**Product Change Notification**

Type of Notification: Changing Capacitor (C103)

LFA150F-□

Fig.2.1 C103

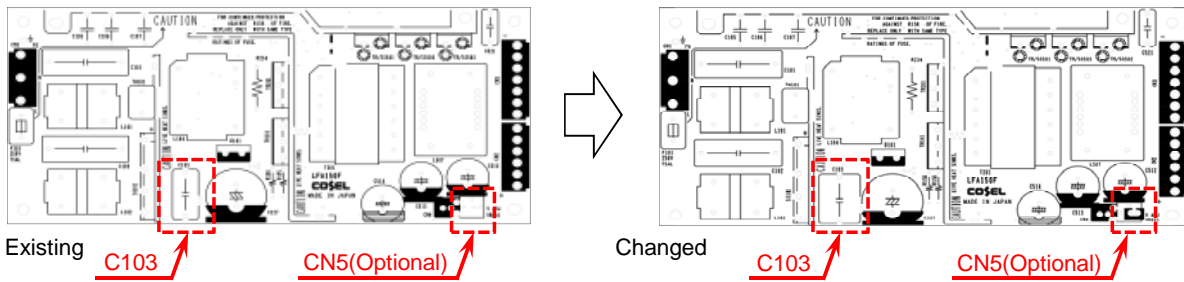
List of components in Table 2.1 will be changed to improve product reliability. Please refer to Fig. 2.1 and 2.2 for changes of the visual appearance. This change does not affect electronic or mechanical specifications, nor does it affect safety standard compliance.

No.	Change parts	Contents	Existing	Changed	Remarks
1	Capacitor (C103)	Manufacturer	OKAYA ELECTRIC INDUSTRIES	OKAYA ELECTRIC INDUSTRIES	Fig.2.1, 2.2
		Type name	AFS450V105K	AFX450V225K	
		Color	Black	Black	
		Rated Voltage[Vdc]	450	450	
		Capacitance[uF]	1.0	2.2	
2	PCB	Silkscreen (C103)	Refer to Fig 2.2		Optional Parts
		Silkscreen (CN5)	Refer to Fig 2.2 (Silkscreen added)
